City of Portland, Oregon
Bureau of Development Services
Land Use Services

**NOTICE OF A TYPE II_x DECISION ON A PROPOSAL IN
YOUR NEIGHBORHOOD**

CASE FILE NUMBER: LU 10-141266 LDP AD

Site Address: 4816 NE Campaign Street

CASE NO. **10-141266 LDP**
EXHIBIT **C.1**

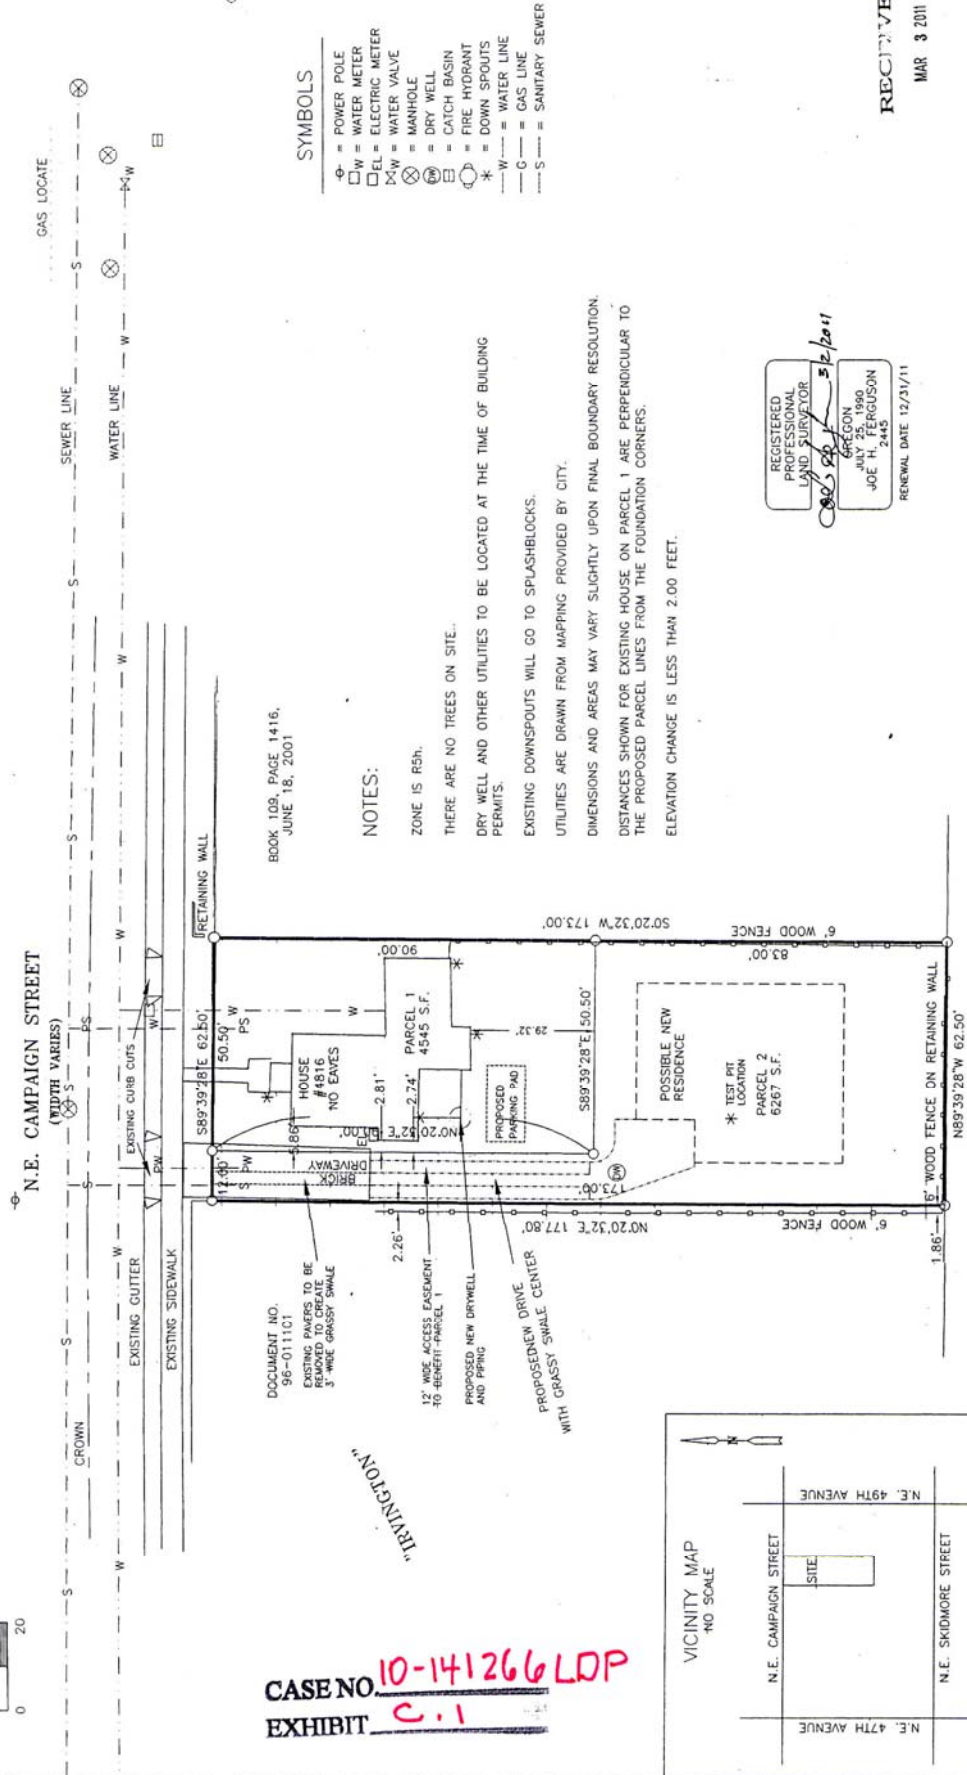
Section 110.220.D.2 Exceptions to the required setbacks allows for flag lots allows lots in front of flag lots to reduce the side building setback along the flag pole lot line to 3 feet. The applicant has requested an adjustment review in order to reduce the west side setback on Parcel 1 along the flag pole lot line from 3 feet to 2.74 feet.

The proposed adjustment would result in a setback that is 4 inches narrower than the required 3 feet along a 9-foot long projection on the west side of the house. This is a minor amount that will not be readily apparent. The rest of the house building wall is approximately 20 feet long and is 4.5 feet from the pole lot line, which exceeds the minimum setback. Fire Bureau has reviewed the proposal and found the proposal to be acceptable subject to fire access requirements. The adjustment will have a minimal effect on light, air and degree of privacy because the length of the house requiring the adjustment is only 9 feet along the 90 foot long pole. Allowing the reduced setback will allow the existing house to remain on the property and will provide enough space for the required outdoor area.

The applicant has proposed a 2-parcel partition, one standard lot and one flag lot, as shown on the attached preliminary plan, Exhibit C. 1. This decision includes approval of an Adjustment to reduce the side setback from 3 feet to 2.74 feet along the flag pole property line for the existing house to remain on Parcel 1. As discussed in this report, the relevant standards and approval criteria have been met, or can be met with conditions.

Approval of an Adjustment to the west side setback on Parcel 1 for the existing house from 3 feet to 2.74 feet along the flag lot pole property line, as shown on Exhibit C.1.

Approval of a Preliminary Plan for a 2-lot partition that will result in one standard lot and one flag lot, as illustrated in Exhibit C.1, subject to the following conditions.

1. A Private Access Easement over the “*flag pole*” portion of Parcel 2 for the benefit of Parcel 1 shall be shown and labeled on the final plat. The easement shall allow shared use of this area for all of the purposes that a driveway would be typically used for.
2. A recording block for each of the legal documents such as maintenance agreement(s) and acknowledgement of special land use conditions the Private Access Easement over the flag pole portion of Parcel 2 as required by Condition C.3 and C.8, below. The recording block(s) shall, at a minimum, include language substantially similar to the following example: “*A Declaration of Maintenance Agreement for a Private Access Easement has been recorded as document no. __ Multnomah County Deed Records.*”

2. A new sanitary connection to the main in NE Campaign is required for the existing house and must be entirely on Parcel 1. Plumbing and connection permits for the new connection and the sewer cap must be finalized prior to final plat approval.

6. A parking space shall be installed on Parcel 1, in conformance with the applicable requirements of the Portland Zoning Code. A copy of the final inspection approval of a Zoning Permit shall be submitted, documenting that the parking space has been installed within the area to become Parcel 1. The new parking space must also be shown on the supplemental plan.
